UNITED STATES PATENT AND TRADEMARK OFFICE

APPLICATION NO.	FILING DATE	FIRST NAMED INVENTOR	ATTORNEY DOCKET NO.	CONFIRMATION NO.
10/516,346	11/30/2004	Yoshie Nishikawa	36856.1302	9508

Office Action Summary	Application No. 10/516,346	Applicant(s) NISHIKAWA ET AL.	
	Examiner Anh T. Mai	Art Unit 2832

DETAILED ACTION

Fig. 25 b

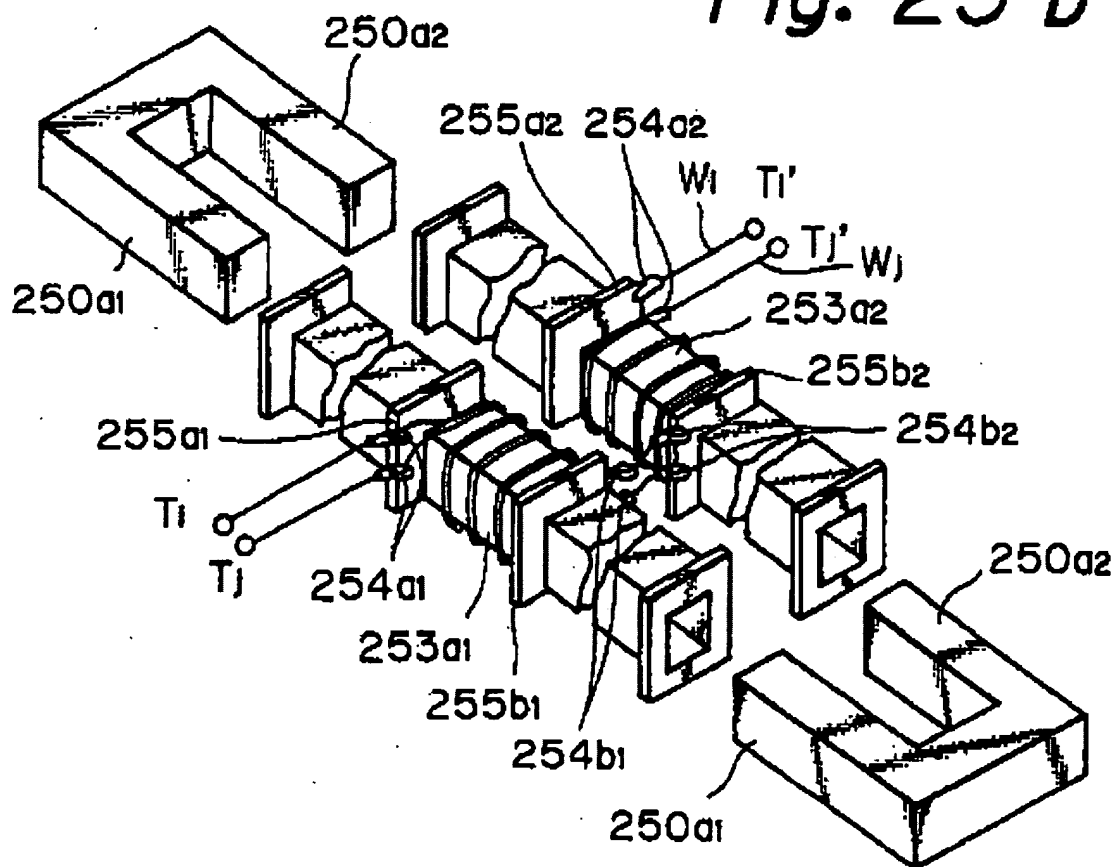
As in claims 6, 9, 14, 19 Takagi discloses the first bobbin 253_{a1} and second bobbin 253_{a2} including the flange portion at both ends of the cylindrical body portion thereof, and outer periphery of the flange portion 255_{a1} of the first bobbin contact with outer periphery of outer flange portion 255_{a2} of the second bobbin; see fig. 25b.

As in claims 15, 26 figure 25B of Takagi shows the core members defined a closed magnetic path in which leading ends of the leg portion abut against each other.
